Product Change Notice (PCN)

Subject: Package change for ISL72991* products.

Publication Date: 5/8/2020

OLD KAT package

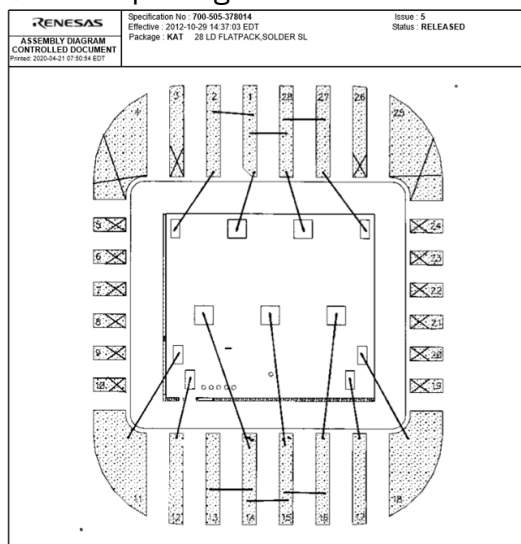
New package eliminates 6 intra-package wire bonds used to daisy chain common pads. New package electrically connects previously daisy chained pads by increasing pad area. No change to die-to-package wirebonds or external pin definitions. See diagrams.
